Addendum No. 2 to IFB #25-76

Replacement of Brown School Boilers

Re: Addition to Scope, Questions and Answers, and Revised Price Form

Photo of Existing Boiler Feed Tank Data Plate

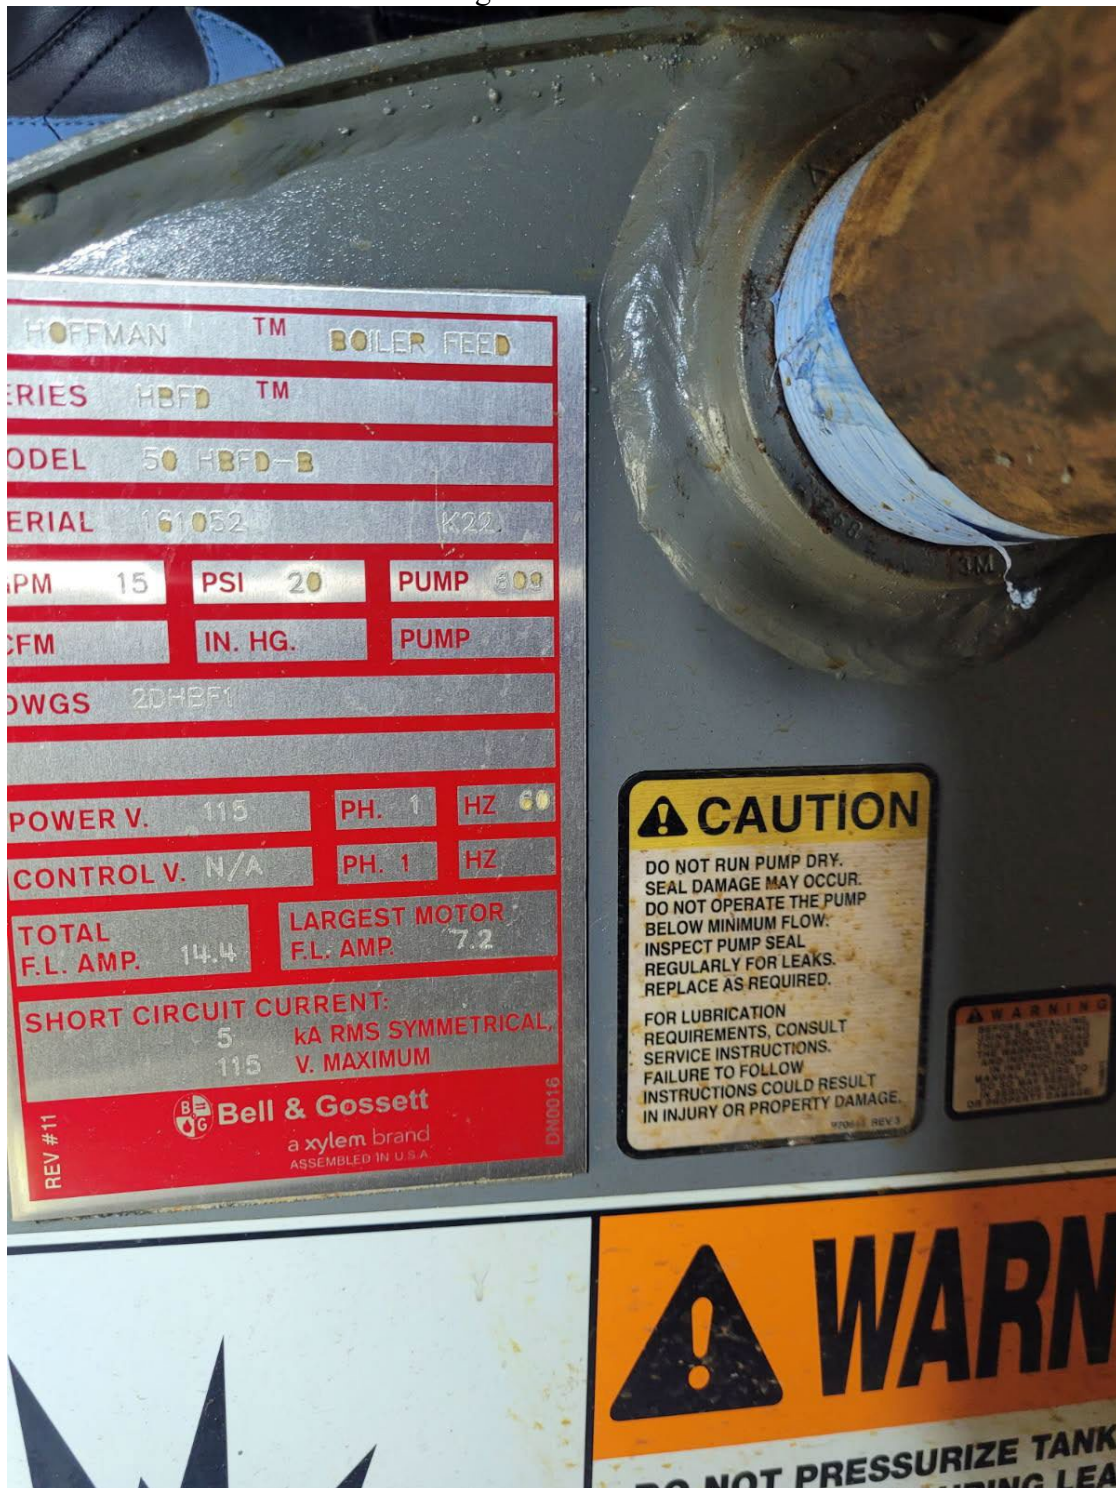
Question: Will the existing boiler feed tank (BFT) be demo'd, and a new condensate receiver tank installed?

Question: How should the Contractor bid if the boiler feed tank needs to be replaced?

Question: Is the condensate receiver big enough? Where would condensation receiver tank go if it needs to be replaced?

Question: If the boiler feed tank is removed from the pit and is found to be in poor condition and requires replacement, can this be listed as an alternate price in the actual bid so all parties in the process are bidding equally and there is no controversy?

- Remove and set aside the existing BFT,
- Provide and install a new duplex CRT with mechanical alternating pump switch,
- Reinstall the BFT in a new location other than the current sump pit location,
- Pipe the CRT discharge into the BFT, and
- Provide and install new alternating pump control/starter equipment for the BFT.
- Although the tank is believed to be in good condition and reusable, the condition cannot be fully determined until the tank is removed from its current location.
 - The Contractor should bid the cost of a replacement tank as Add Alternate #1.
 - If the existing tank is too small, the contractor is to determine appropriate tank size during the bid process and include the cost of an appropriately sized tank in their base price. Please see attached photo of the boiler feed tank data plate.

Answer: Although the tank is believed to be in good condition, the condition cannot be fully determined until the tank is removed from its current location. The Contractor should bid the cost of a replacement tank as Add Alternate #1. Please see attached photo of the boiler feed tank data plate.

Answer: There is no CRT on the existing system. The contractor will supply and install a new duplex CRT that will discharge into the BFT. The CRT will include automatic alternating pump switch/motor starters. Please see attached photo of the boiler feed tank data plate.

Answer: Although the tank is believed to be in good condition, the condition cannot be fully determined until the tank is removed from its current location. If BFT is in poor condition, the new tank should be bid as an add-alternate. Please see attached photo of the boiler feed tank data plate.
